[Signature]
 02 OCT 06
RECORD DRAWING

No.	Revision	By	Date
AVALON PARK 3RD STORM WATER DRAIN NO. 265 KEY MAP AND GENERAL NOTES JAMES L. ARMOUR, P.E.-CITY ENGINEER CITY OF WICHITA PROJECT NO. 468-84012 Professional Engineering Consultants, P.A. 303 S. TOPEKA • WICHITA, KANSAS 67202 316-262-2691 • FAX 316-262-3003			
Designed by	BDB, BLB	Job No.	35-05258
Drawn by	BJS	Date	February 2005
			Sht. 2 of 35

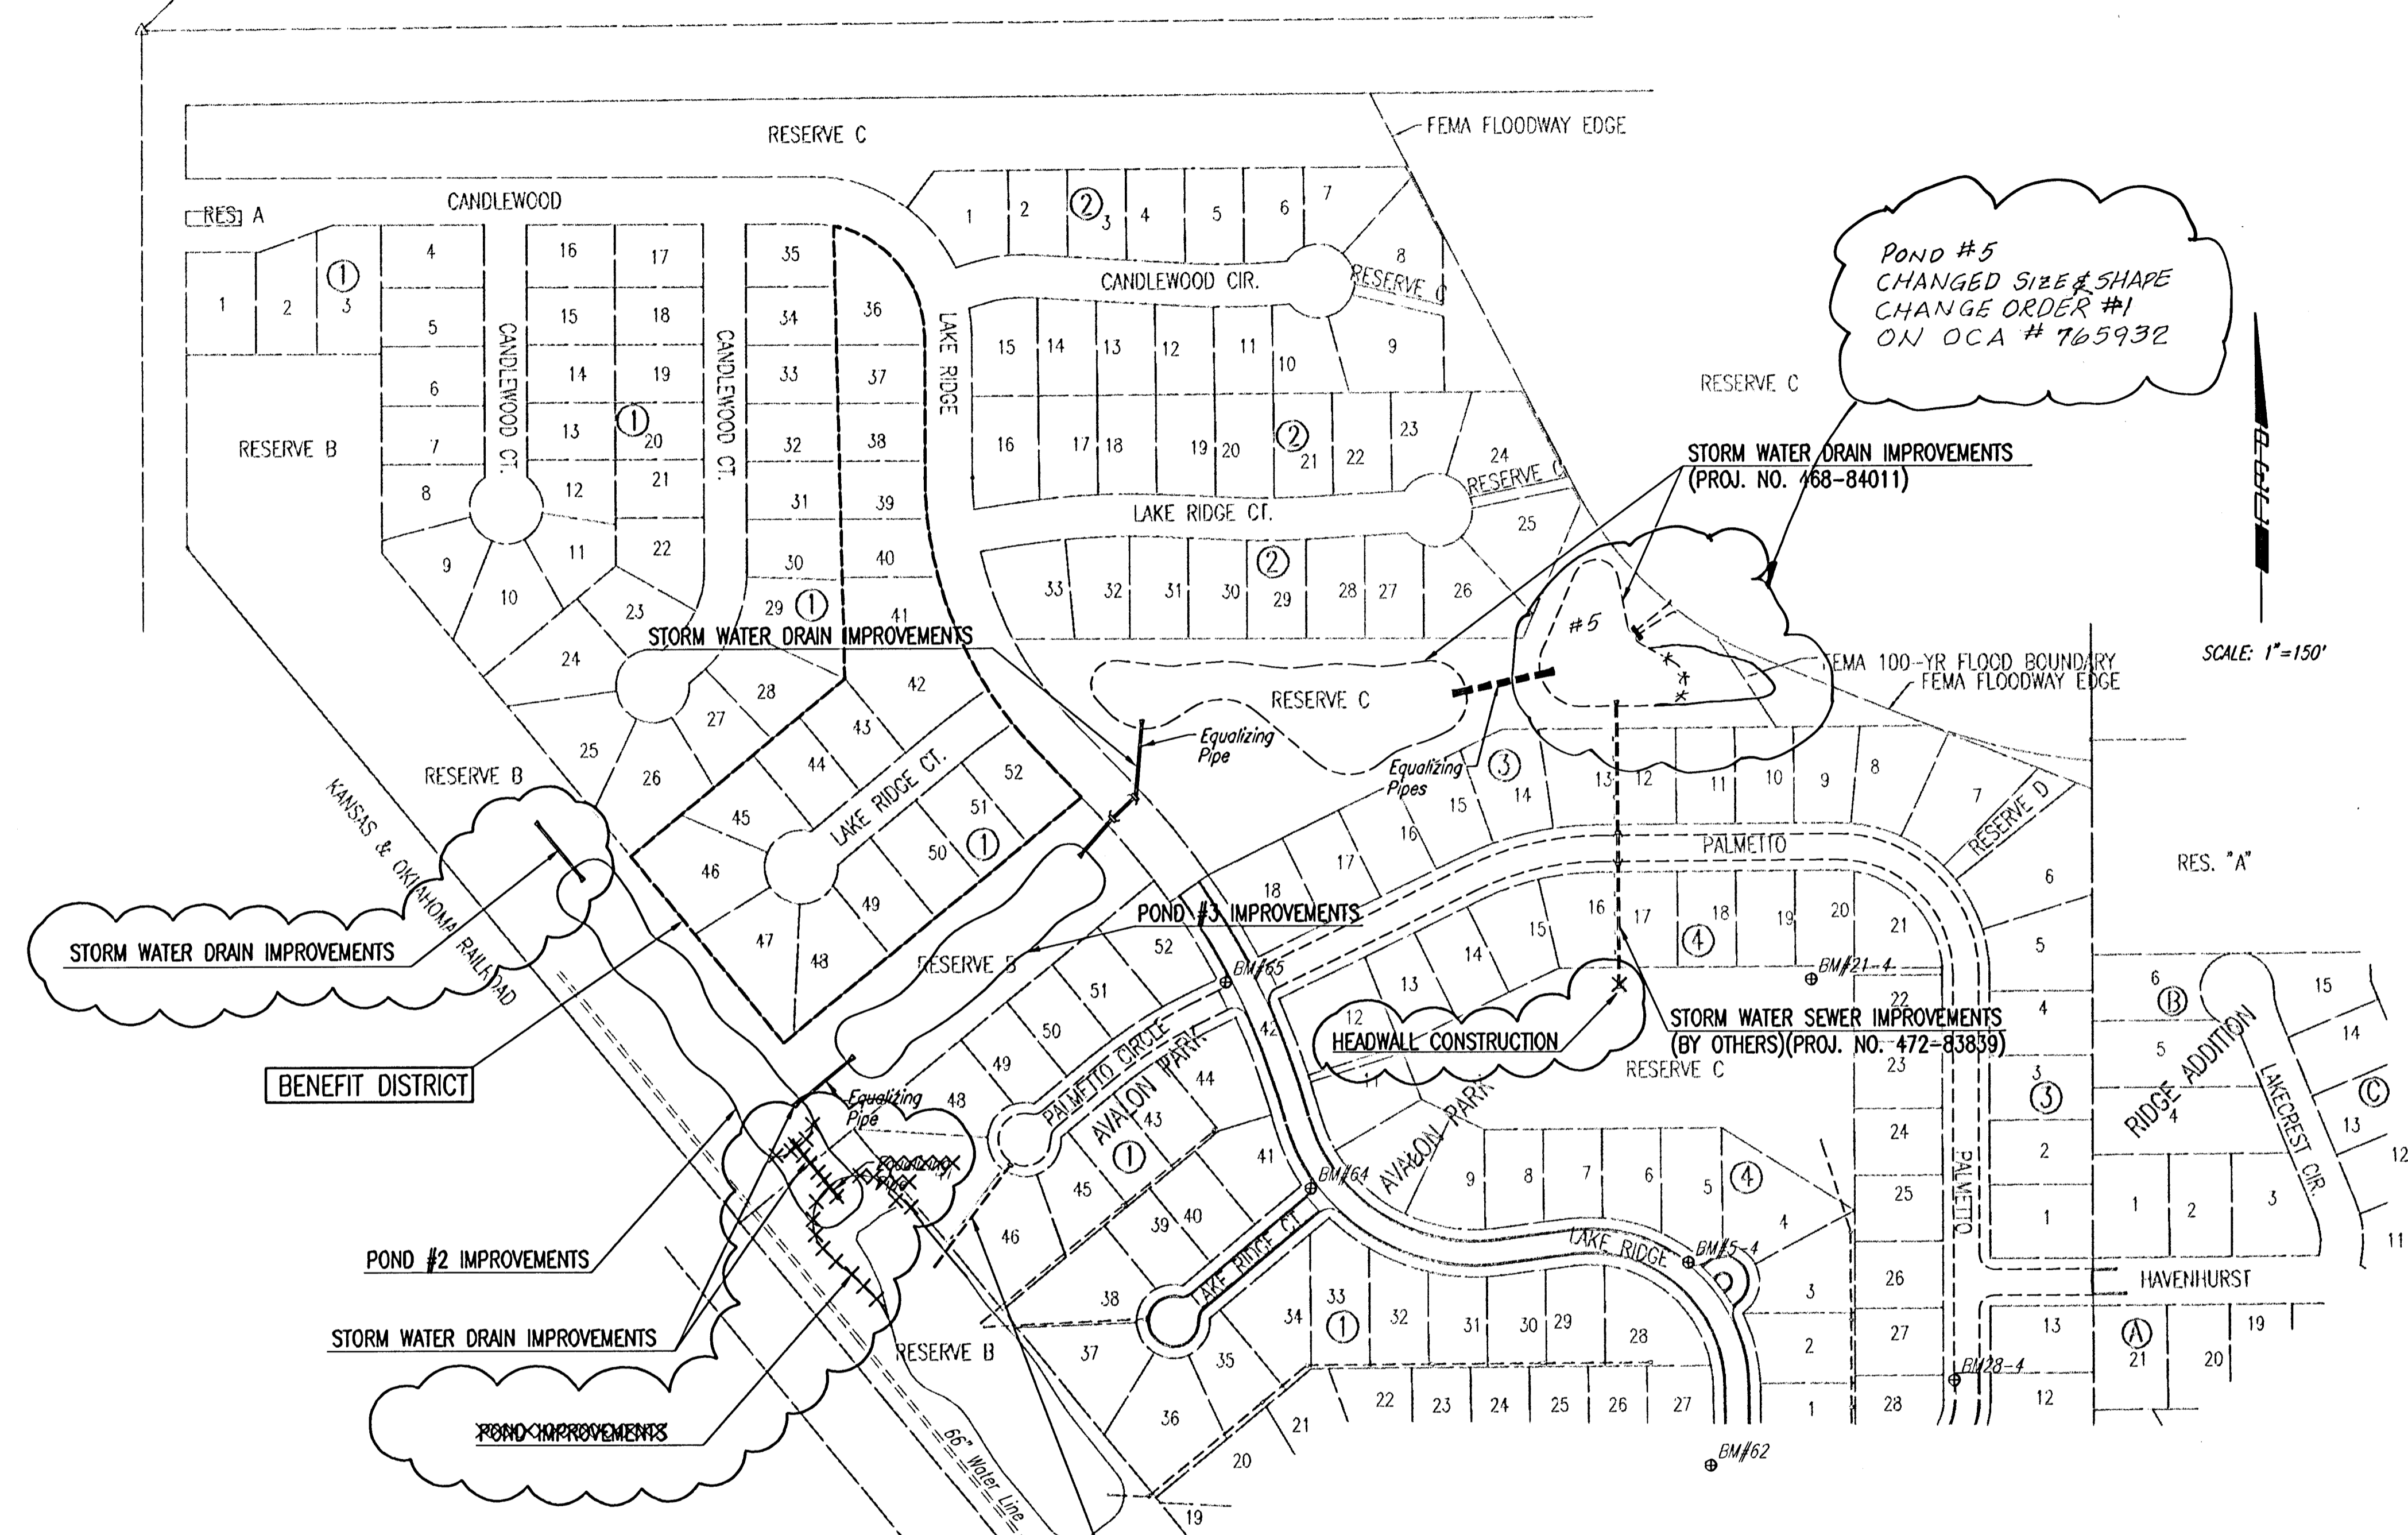
POND #5
 CHANGED SIZE & SHAPE
 CHANGE ORDER #1
 ON OCA # 765932
